MAY 1987 ADDENDA

NEBRASKA PUBLIC POWER DISTRICT

COOPER NUCLEAR STATION

INSERVICE INSPECTION PROGRAM FOR
ASME CLASS 1, 2, AND 3 COMPONENTS

WELD TYPE DRAWINGS - TAB 13

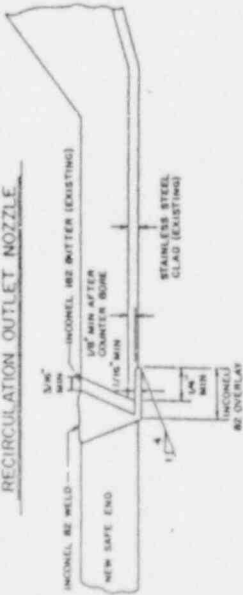
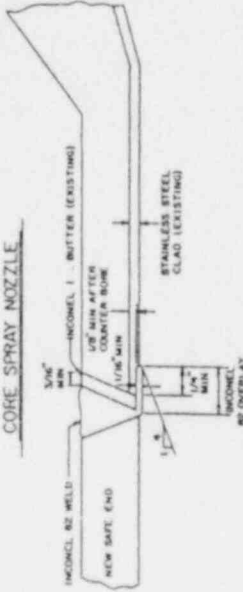
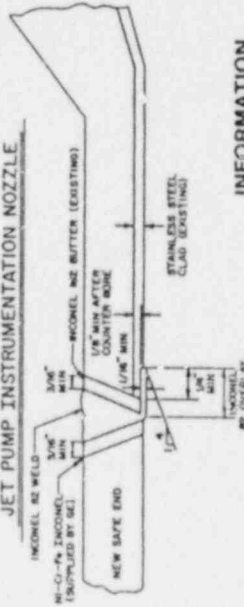
<u>SECTION</u>	<u>PAGE(S)</u>	<u>DESCRIPTION</u>
WELD TYPE DRAWINGS - TAB 12	Replace V12A with CNS-NB-1	Pipe replacement DC.
WELD TYPE DRAWINGS - TAB 13	Replace V13A with CNS-NB-1	Pipe replacement DC.
WELD TYPE DRAWINGS - TAB 16	Replace V16A with CNS-NB-1	Pipe replacement DC.
WELD TYPE DRAWINGS - TAB 19	Replace V19A with CNS-NB-1	Pipe replacement DC.
WELD TYPE DRAWINGS - TAB 31	Add Tab 31 and Drawing CNS-PPG-1 Sheet 1	Pipe replacement DC.
WELD TYPE DRAWINGS - TAB 32	Add Tab 32 and Drawing CNS-PPG-1 Sheet 2	Pipe replacement DC.
WELD TYPE DRAWINGS - TAB 33	Add Tab 33 and Drawing CNS-RR-25	Pipe replacement DC.
WELD TYPE DRAWINGS - TAB 34	Add Tab 34 and Drawing CNS-RR-26	Pipe replacement DC.
ISI DRAWINGS	1	Change index to reflect pipe replacement DC.
ISI DRAWINGS - TAB 1	Replace existing with CNS-CS-3	Pipe replacement DC.
ISI DRAWINGS - TAB 2	Replace existing with CNS-CS-4	Pipe replacement DC.
ISI DRAWINGS - TAB 3	Replace existing with CNS-RWCU-3	Pipe replacement DC.

ISI DRAWINGS - TAB 22

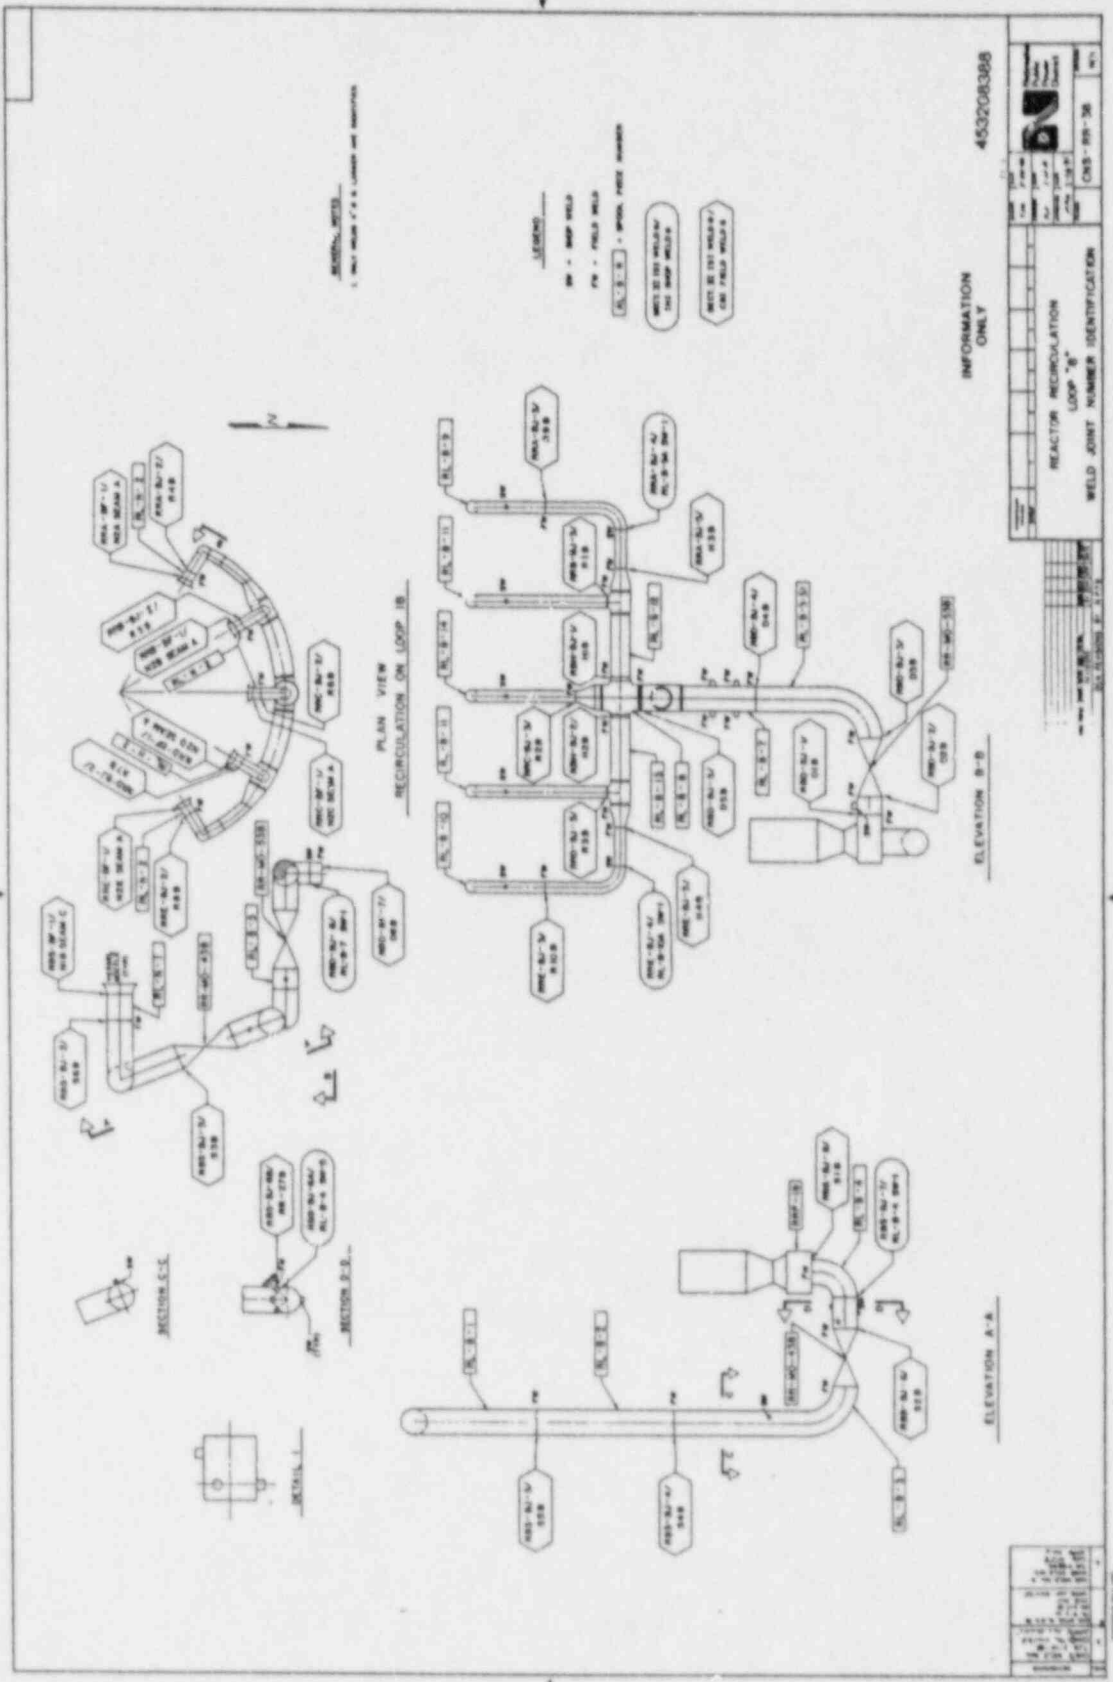
ISI DRAWINGS - TAB 8	Replace existing with CB&I 10	Pipe replacement DC.
ISI DRAWINGS - TAB 19	Leave tab, delete drawing.	Pipe replacement DC.
ISI DRAWINGS - TAB 20	Replace existing with CNS-RR-37	Pipe replacement DC.
ISI DRAWINGS - TAB 21	Leave tab, delete drawing.	Pipe replacement DC.
ISI DRAWINGS - TAB 22	Replace existing with CNS-RR-38	Pipe replacement DC.

ISI DRAWINGS - TAB 39

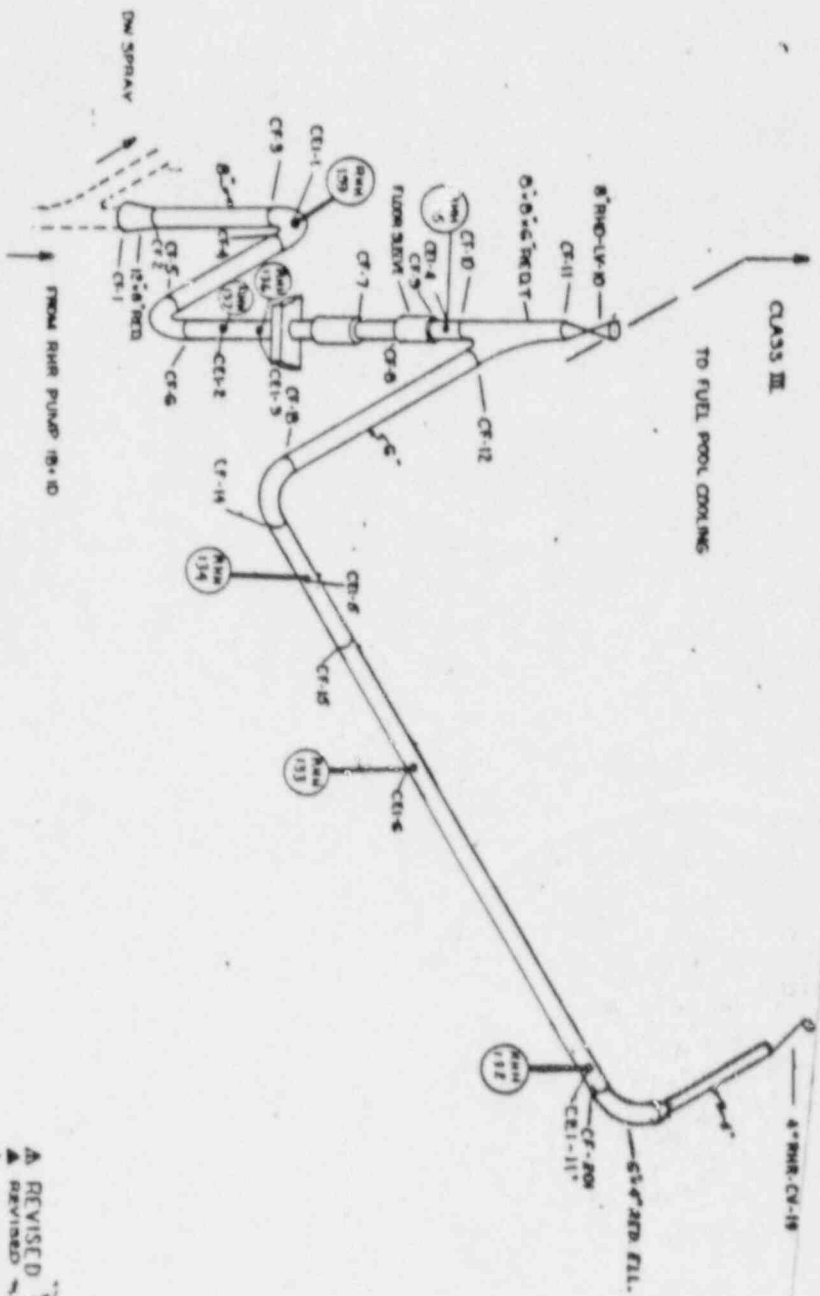
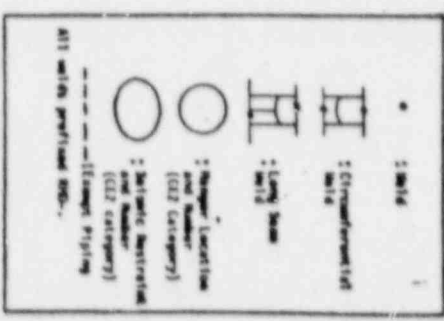
<u>SECTION</u>	<u>PAGE(S)</u>	<u>DESCRIPTION</u>
ISI DRAWINGS - TAB 23	Leave tab, delete drawing.	Pipe replacement DC.
ISI DRAWINGS - TAB 39	Replace existing drawing with revised drawing.	Head spray DC.
W81 RELIEF REQUESTS	Replace existing index with new index.	Relief Request #2 was not granted per the NRC SER for Cooper's ISI Program.
2ND INTERVAL NIS-1 FORMS	Add pp. 1 of 61 through 7 of 61.	Fall 1986 outage NIS-1 Form.
EXAM COMPONENT INDEXES	Add pp. 1 of 54 through 54 of 54	Fall 1986 outage exam component index.
CORRESPONDENCE	Replace existing index with new index.	Add Tabs 8, 9, 10.
CORRESPONDENCE - TAE 9	Add Tab 9 and the May 1987 addenda documentation.	May 1987 addenda.
CORRESPONDENCE - TAB 8	Add Tab 8 and the SER for Cooper's ISI Program.	Add SER.
CORRESPONDENCE - TAB 10	Add Tab 10 and 316 NG material specification.	New material specification per pipe replacement DC.
